Historic Architectural Review Commission

Staff Report Item 2

Meeting Date:	October 28, 2014
Applicant:	Stefano de Luca, Architect
Application Number:	H14-01-1351
Address:	#500 Duval Street
Description of Work:	Renovation of storefront windows. New egress door and fire safety equipment at Old Kress Building.
Building Facts:	<p>The historic building is listed as a contributing resource. The two story masonry vernacular structure was built in 1918. The building is located on the south west corner of Duval and Fleming Streets. The structure will be converted into a CVS Store. The historic Kress signs will not be altered or removed.</p> <p>In October 23, 2012 the Commission approved plans for revisions to the first floor façade in order to match original openings. The design was never executed.</p>
Guidelines Cited in Review:	Commercial Storefronts and Signage (page 46), specific guidelines 1, 2 and 5.

Re: **HARC Certificate of Appropriateness**
CVS #10169
500 Duval Street
Key West, FL 33040

1 SCHEME-3 ELEVATION (NORTH)
SCALE: 1/8"=1'-0"

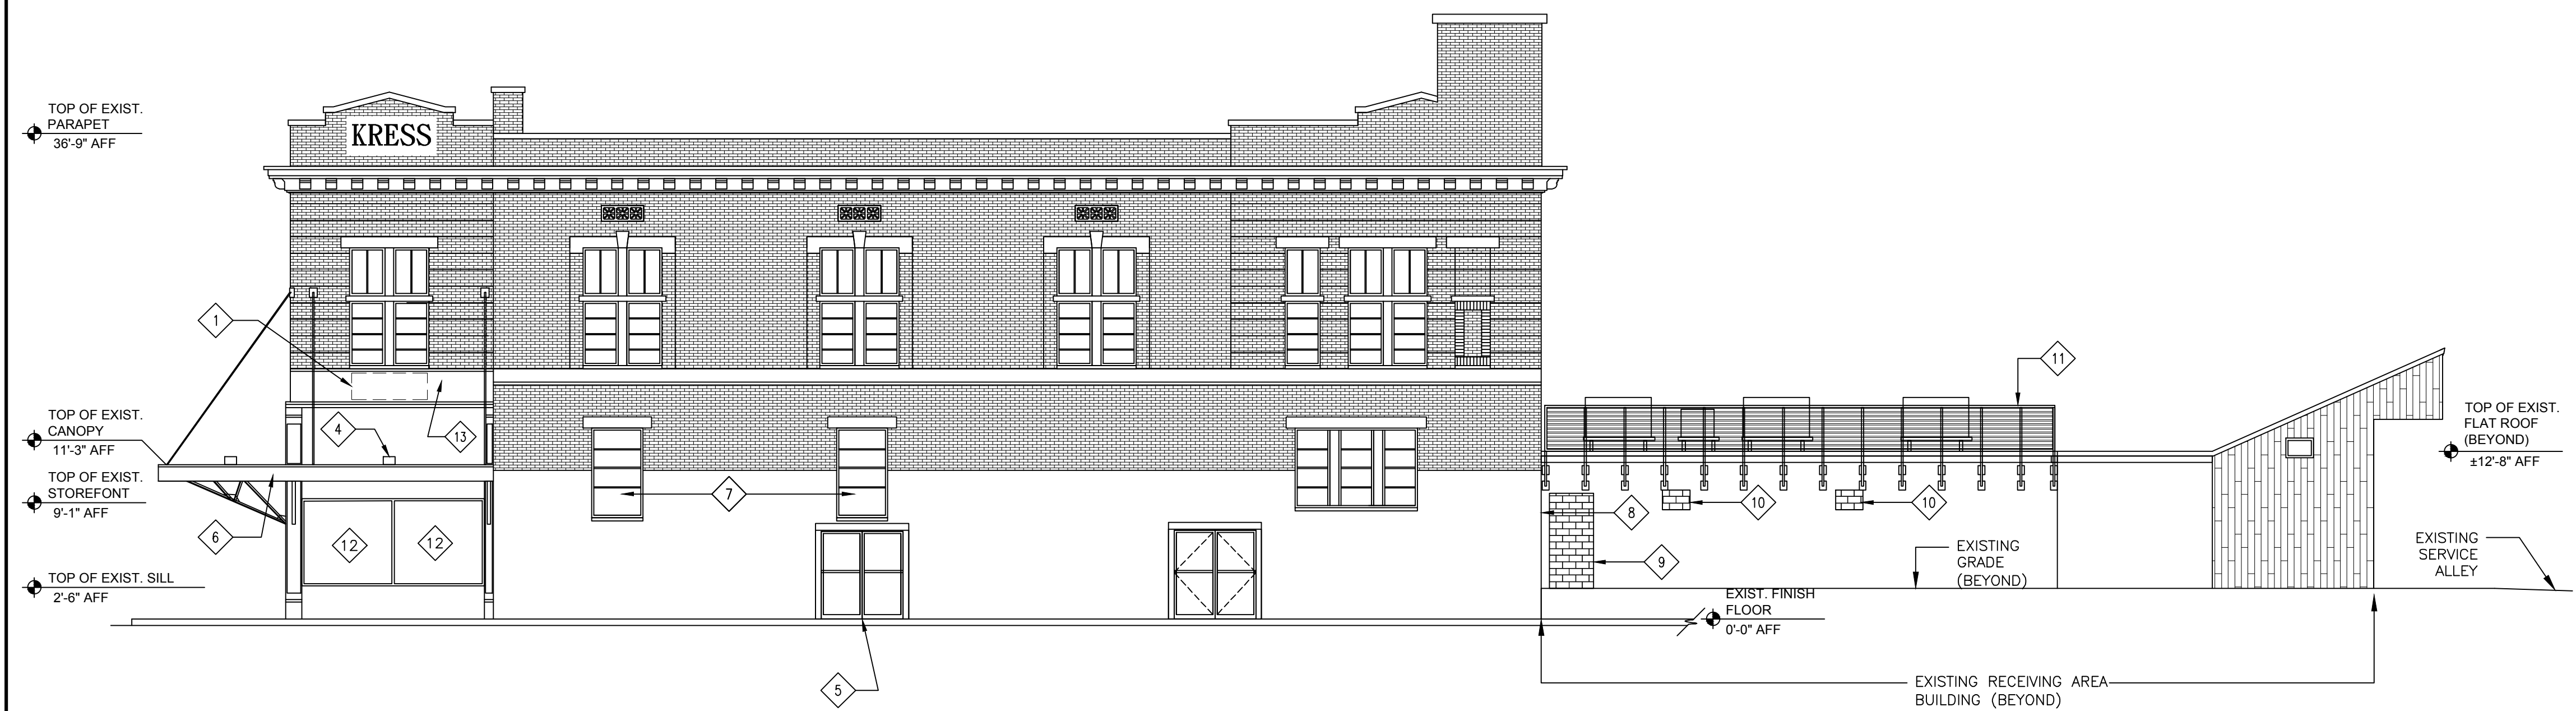
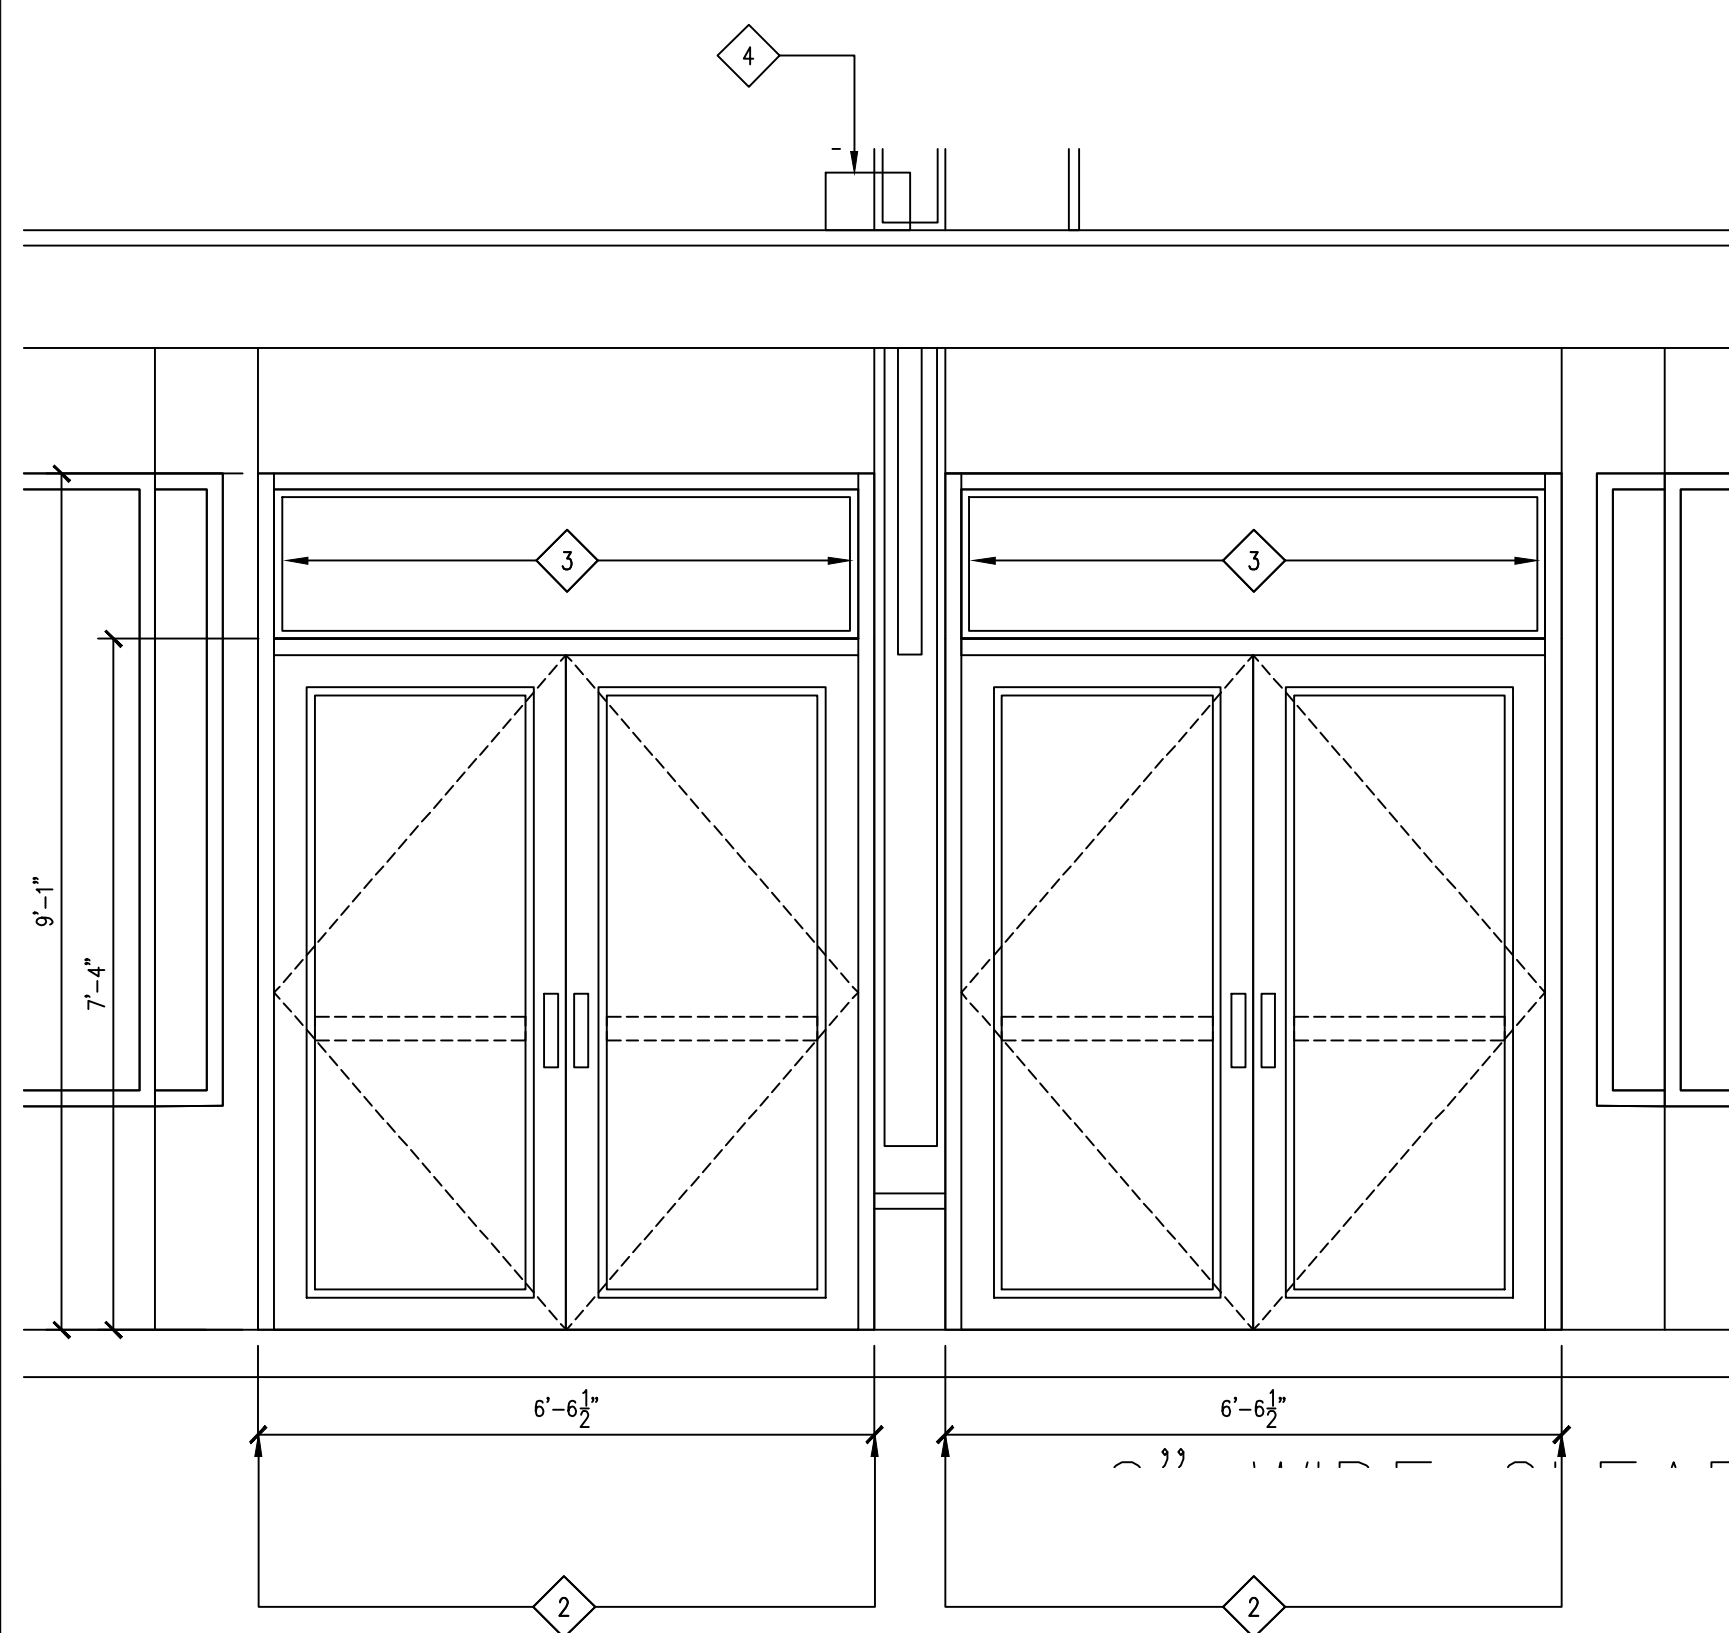
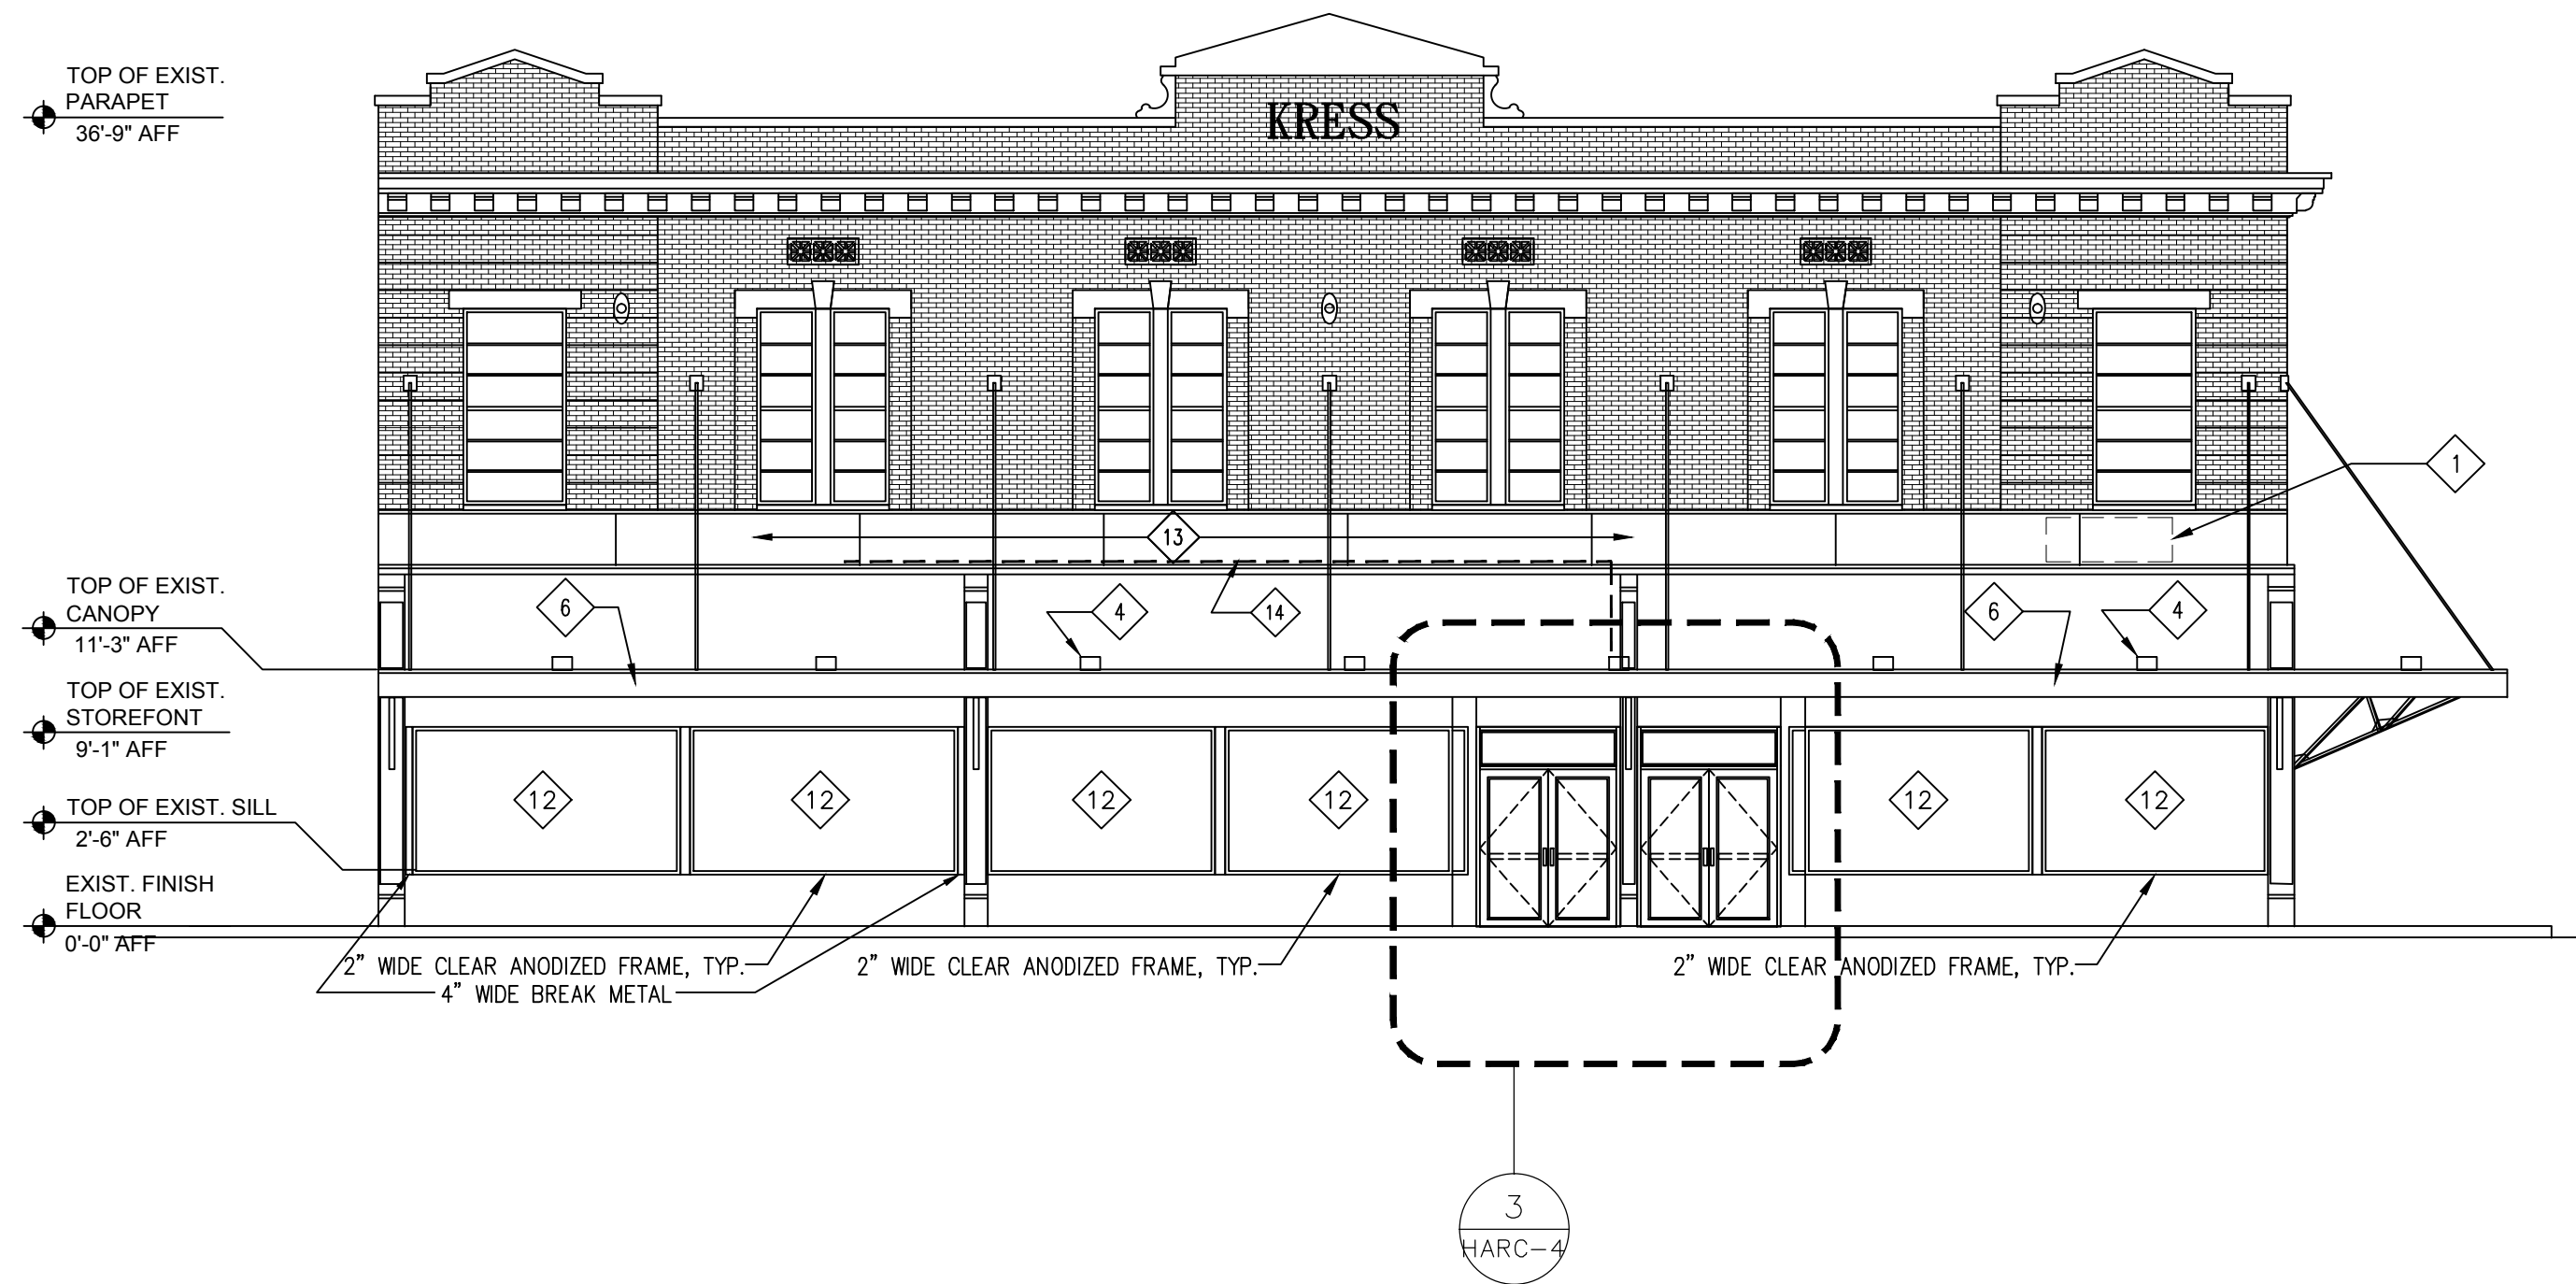
Scheme 3- Current single panels of glass on Duval Street will be replaced with similar size glass panels, after widening the leftmost center column. The Fleming storefront will be replaced to match existing number and size of panels.

In regards to item 4(c), we should have no issues providing the category II safety glazing for both schemes "A" & "B". If HARC will allow us to widen the one column on Duval street, then providing category II safety for "Scheme C", will also not be an issue.
